## **MEMORANDUM**

**RE:** Percolation Certification Plan Comments:  
13942 Clarksville Pike – *El Sawi Property*

**13942  
CLARKSVILLE ROAD**

TITLE:  
**PERCOLATION CERTIFICATION PLAN**

**PERCOLATION CERTIFICATION PLAN**

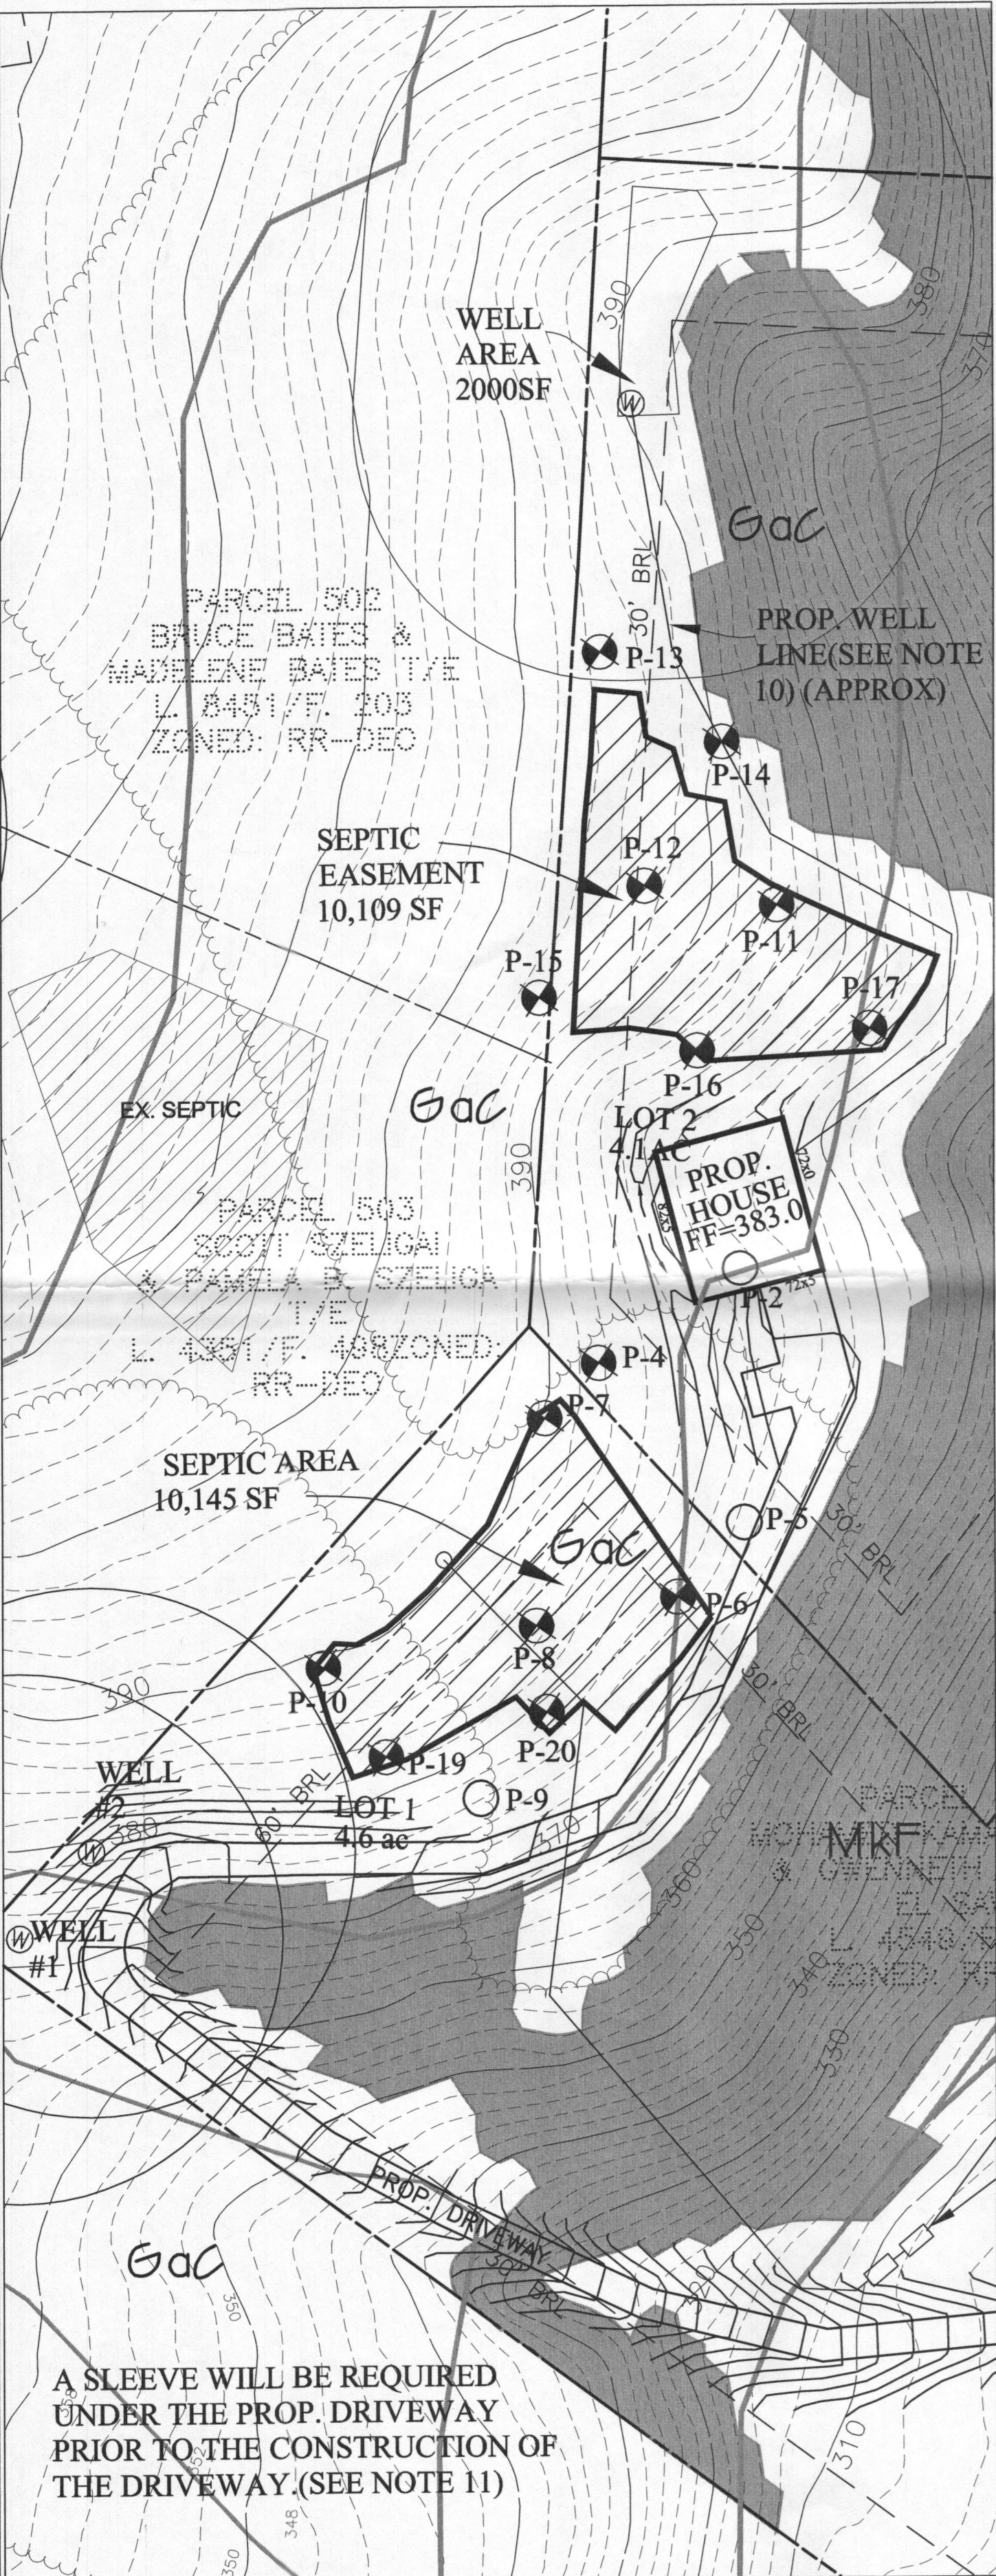
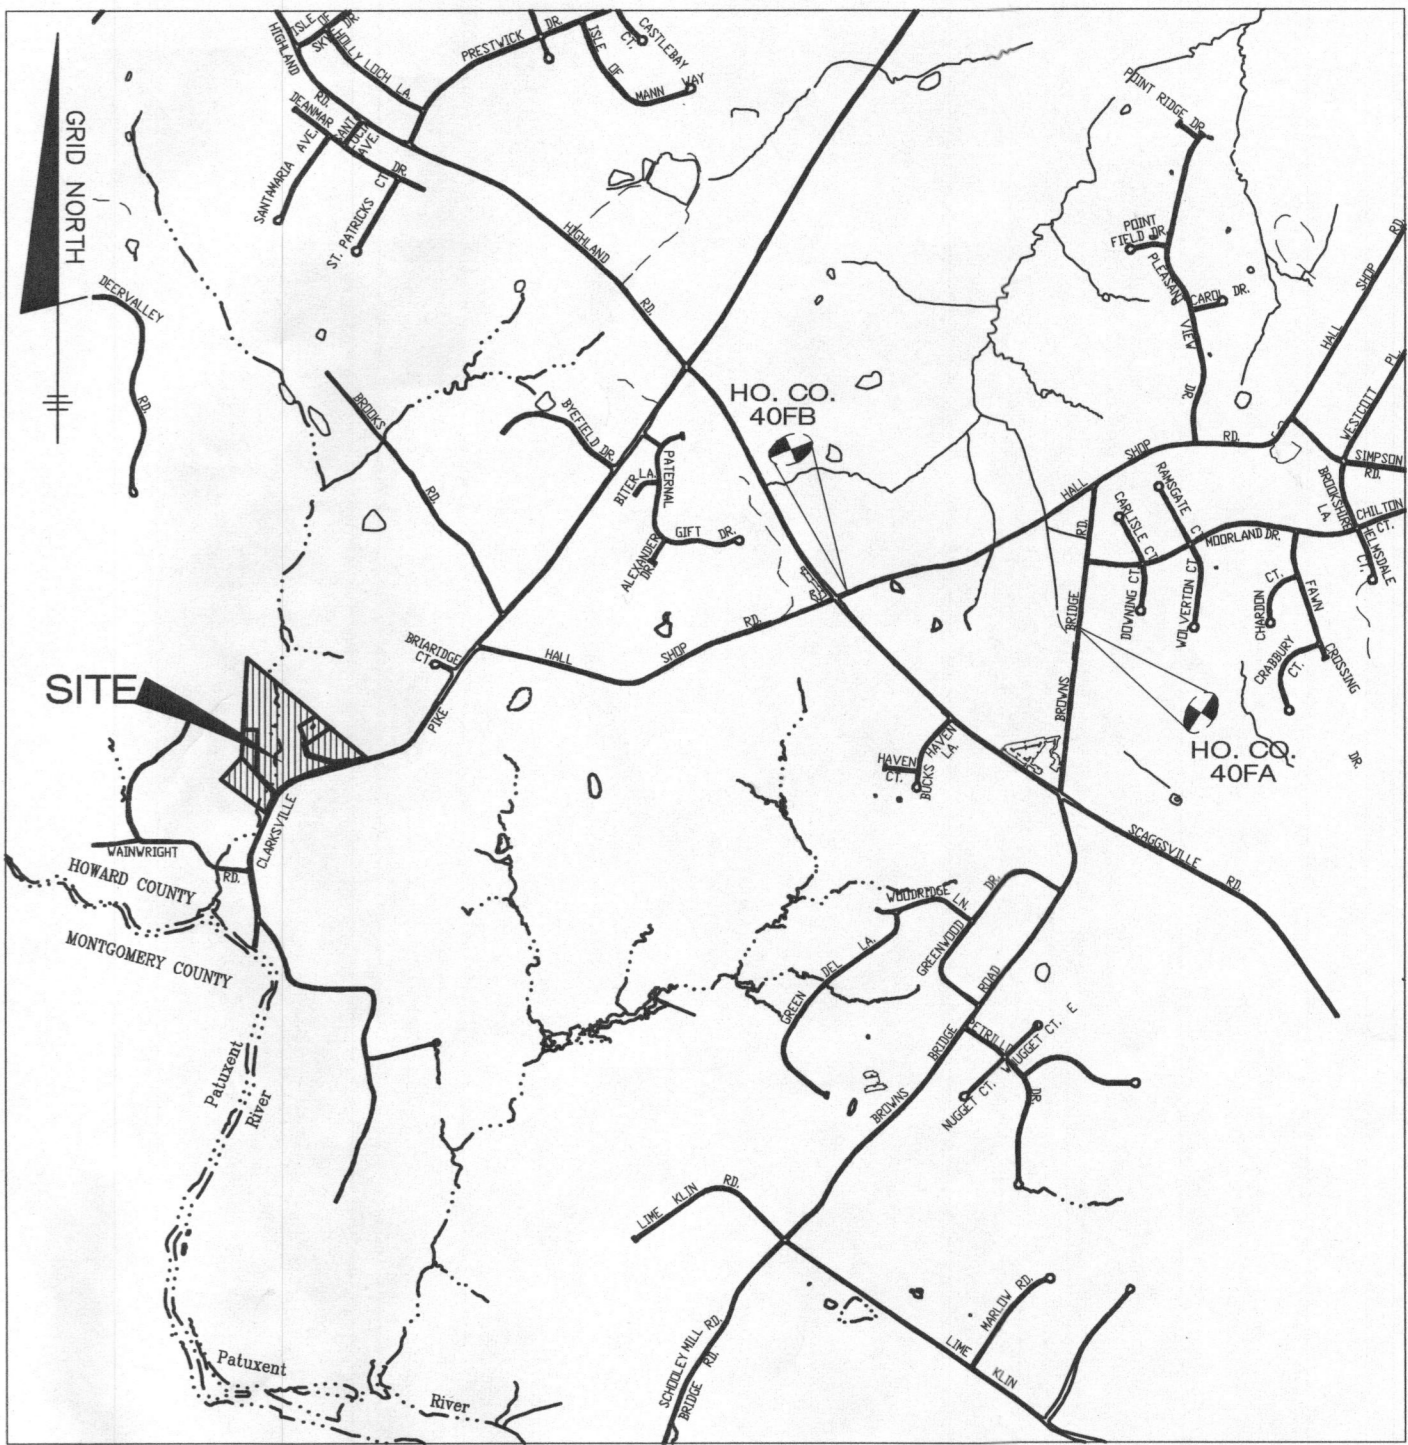
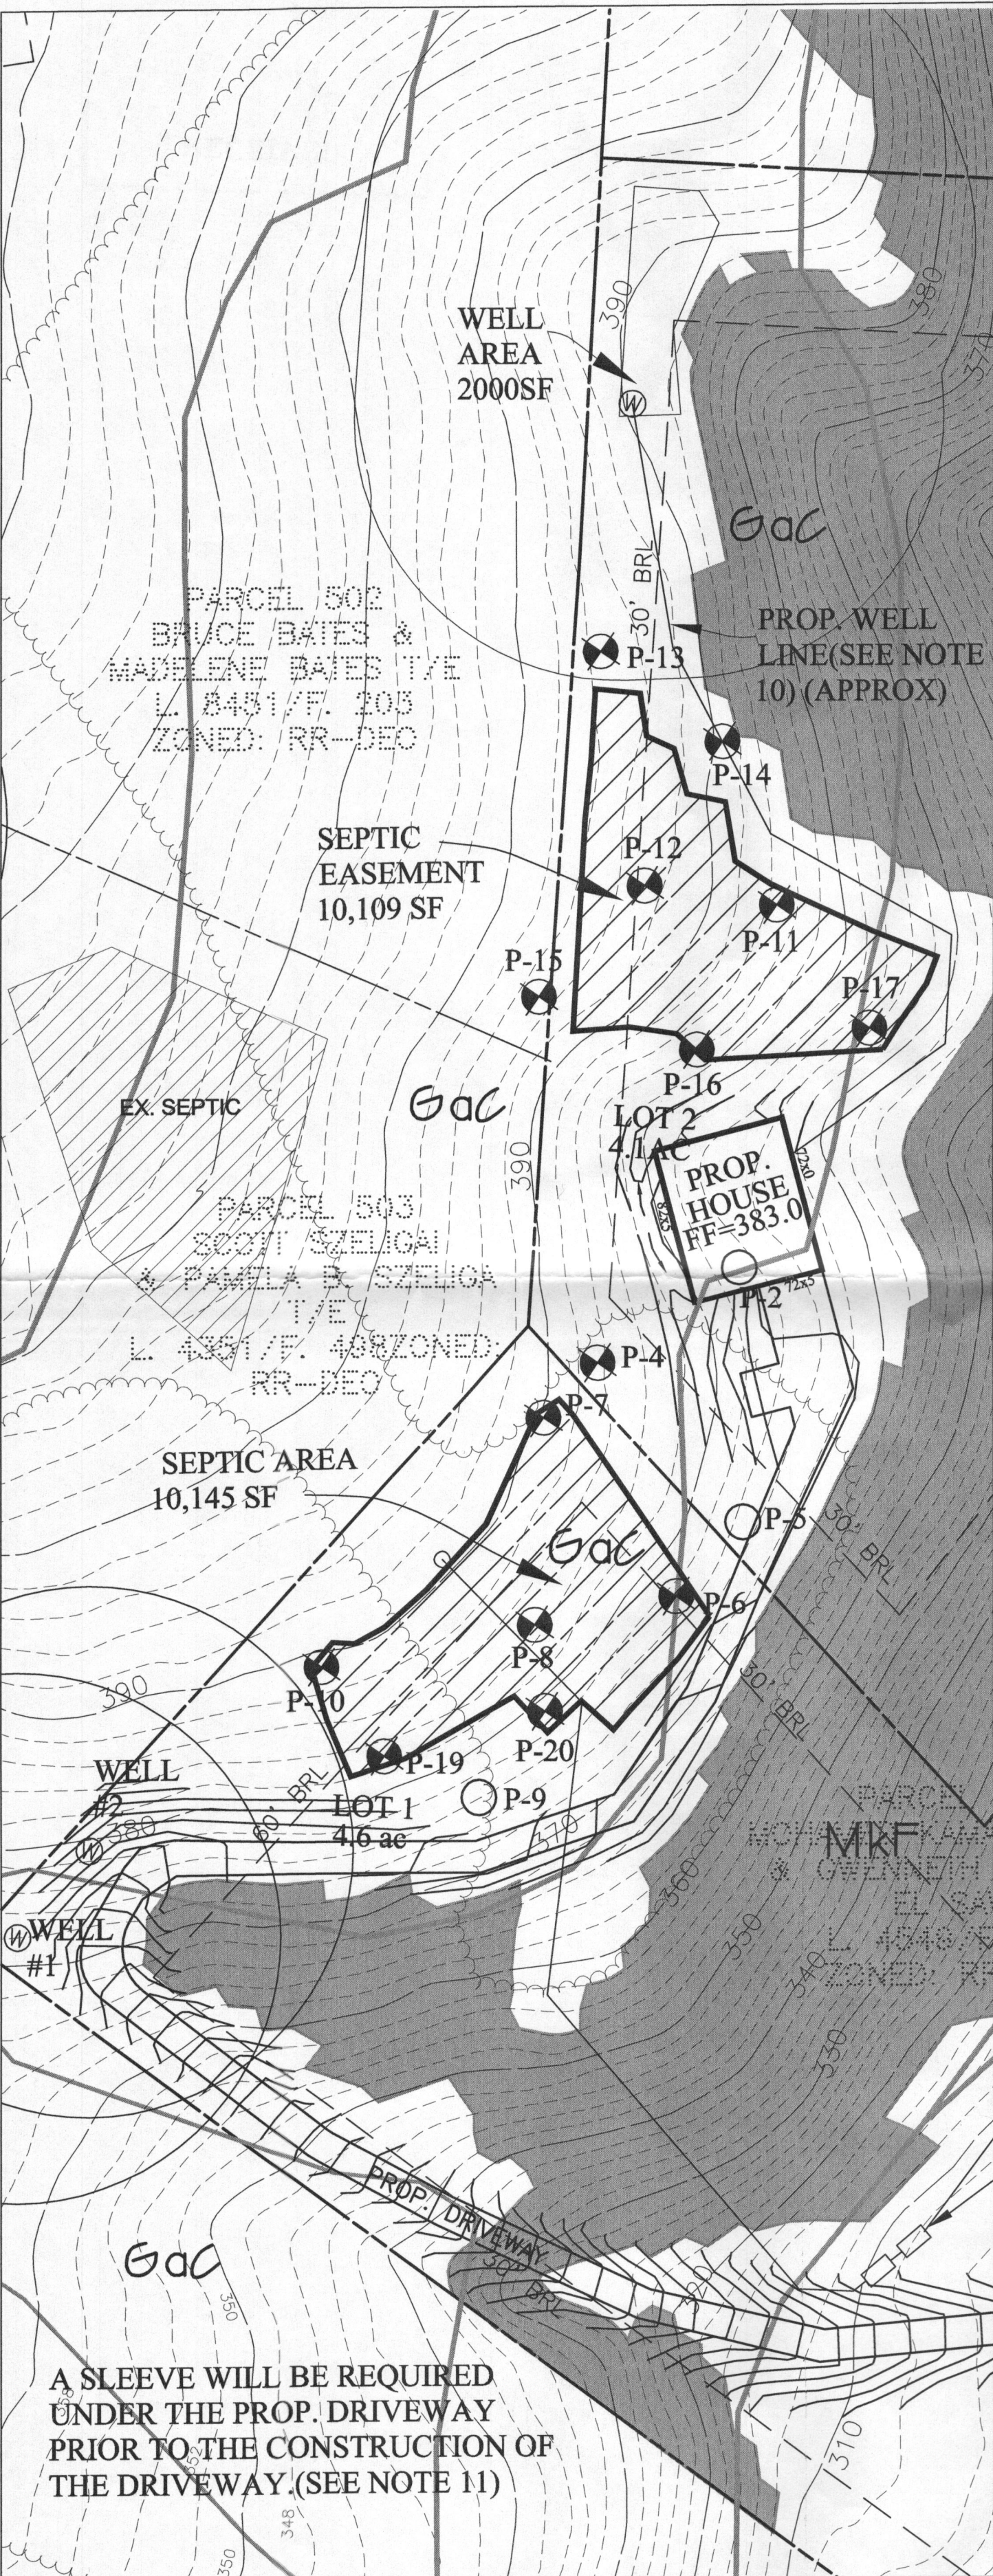
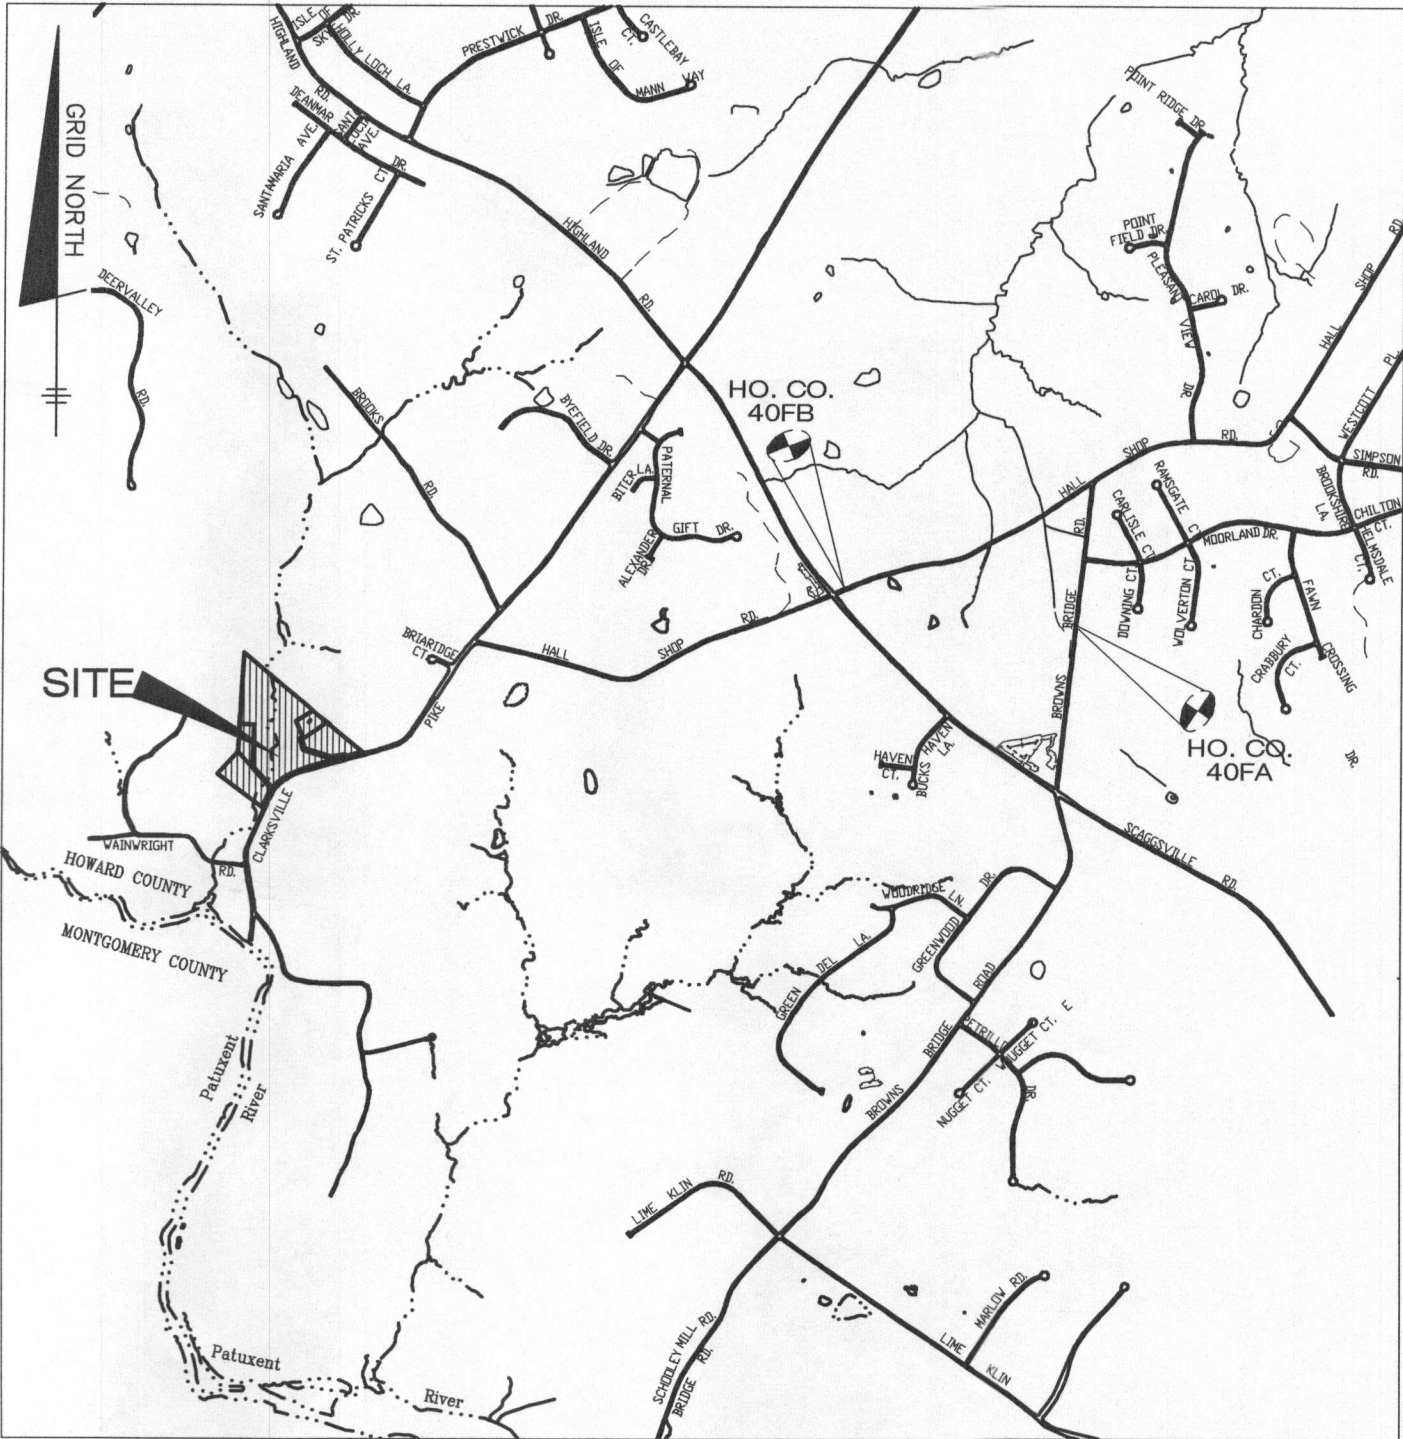
2. Label plan "Subdivision" or indicate a purpose statement.
3. Proposed well site locations 1, 2, and 3 on Lot 1 need to be revised to meet 100' from septic and 200' down-gradient from septic. Move to add 1500ft<sup>2</sup> well box in far southwest corner of property on Lot 1. Proposed drive to Lot 2 may need to be adjusted some.

5. Add note to state Septic Reserve Area (SRA) for Lot 1 must be fenced off and protected prior to proposed drive installation. Protection devices (fencing) must remain in place during the entire construction phases of Lot 2.

6. Add note to state on Lot 2 septic install will require Low Pressure Dosing (LPD).
7. Please add on plan proposed grading for the drive-way install around Lot 1 SRA.

8. On Lot 2, please show the well line proposal to the house. Must meet 10' setback from the SRA. If not, note to state well line on Lot 2 must be sleeved within 10' of SRA.

- 8.) THE SEPTIC RESERVE AREA FOR LOT 1 MUST BE FENCED OFF AND PROTECTED PRIOR TO THE INSTALLATION OF THE PROPOSED DRIVEWAY FOR LOT 2. THE PROTECTIVE FENCING MUST REMAIN FOR THE ENTIRE CONSTRUCTION OF LOT 2 AS WELL.

- 9.) LOT 2 SEPTIC INSTALL WILL REQUIRE LOW PRESSURE DOSING (LPD).
- 10.) THE WELL LINE FOR LOT 2 WILL REQUIRED TO BE SLEEVED WITHIN 10' OF THE SEPTIC RESERVE AREA.

- 11.) PROVIDE A SLEEVE UNDER THE PROPOSED DRIVEWAY FOR LOT 2 PRIOR TO THE CONSTRUCTION OF THE DRIVEWAY. PROVIDE TURN-UPS AT EITHER SIDE FOR MARKERS.
